ViconNet Version 7.0 (Build 22)

General Description

Vicon is releasing ViconNet version 7.0 (Build 22) for ViconNet version 6-based systems. This updated version includes new features and several fixes for problems reported from the field and test lab and improves overall system performance and stability. ViconNet 7.0 (Build 22) includes "Drivers 940."

Recording Management

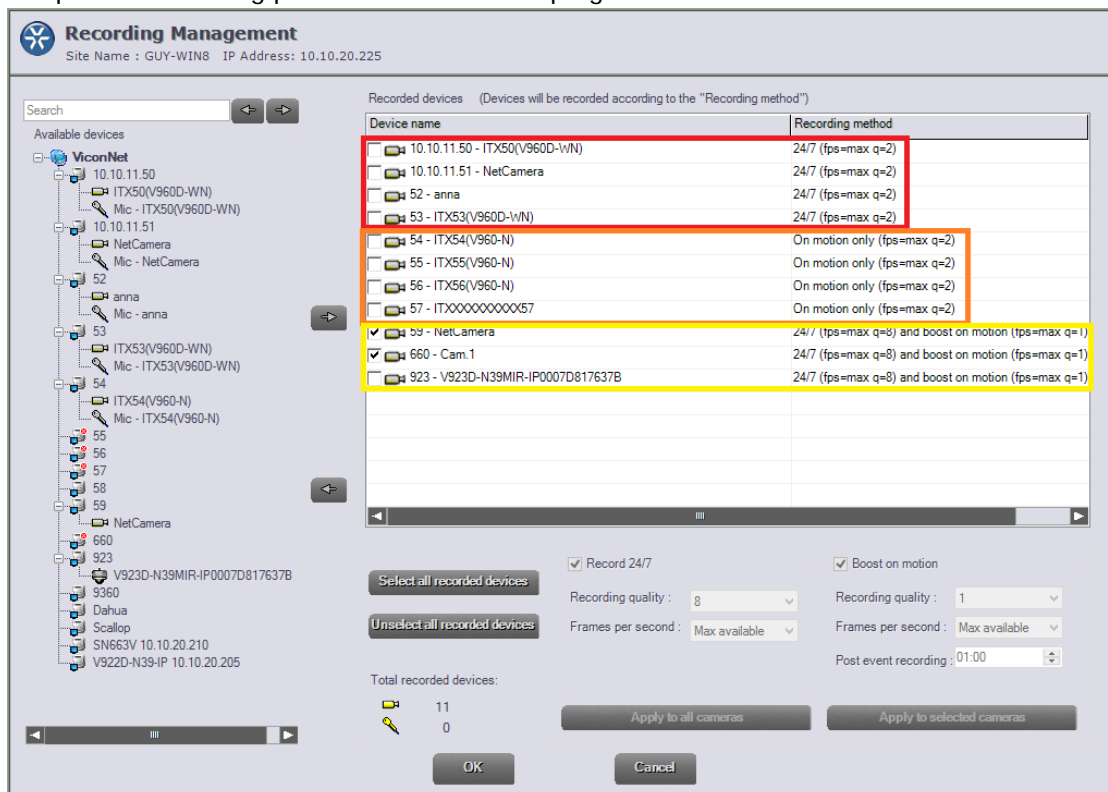
Recording Management setup screen was added to allow quick and easy setup of the recording tasks in the ViconNet NVR/DVR. Unlike the complex programming required when creating a recording macro, the recording manager offers a simple pick-list to select cameras and microphones and three recording options to choose from: 24/7 continuous recording (see below boxed in red), record on motion only (see below boxed in orange) and a combination of continuous recording with a boost to a different FPS and/or resolution on motion (see below boxed in yellow).

The setup screen allows selection of certain camera groups by highlighting and checking additional devices, so settings can be easily applied to all cameras or certain selected ones with a single click of a button.

The Recording Management replaces the auto-record setup screen in Kollektor DVRs and is a new addition to the NVRs. The macro editor and scheduler are still available for display purpose or if complicated recording parameters need to be programmed.
